Planning Commission Staff Report

Project Type: 2nd Amended Site Development Section Plan

Description: **Chesterfield Commons Six, Lot 7B (Courtyard by Marriott):** An Amended Site Development Section Plan, Amended Landscape Plan, Amended Lighting Plan, Amended Architectural Elevations and an Architect's Statement of Design for a 2.807 acre lot of land zoned "C-8" Planned Commercial District located south of Interstate 40 and west of the intersection of Boone's Crossing and Chesterfield Airport Road.

Figure 4 Architectural Elevation as presented at ARB

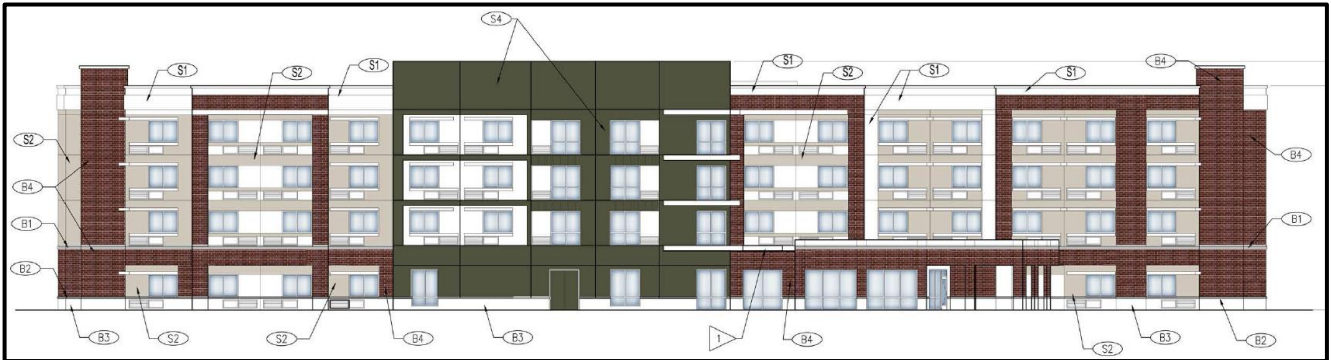
The project was reviewed by the Architectural Review Board (ARB) on April 9th, 2015. A motion to forward the submittal to the Planning Commission with a recommendation for approval with the conditions listed below was passed by a vote of 4-0.

1. Provide additional architectural renderings to better represent the building design.
2. Evaluate opportunities to improve some of the terminations, scale, and proportions of the building materials to create a more cohesive design.

In response to the ARB's recommendations, the Applicant has provided an additional rendering of the east elevation of the building to provide a more complete interpretation of the primary front and rear

building façades. Additionally, the Project Architect revised the Architectural Elevations to address the concerns pertaining to the material terminations, proportions of the vertical façade elements, and overall architectural rhythm of the building. Below is a comparison of the Architectural Elevations as presented at the Architectural Review Board and as revised.
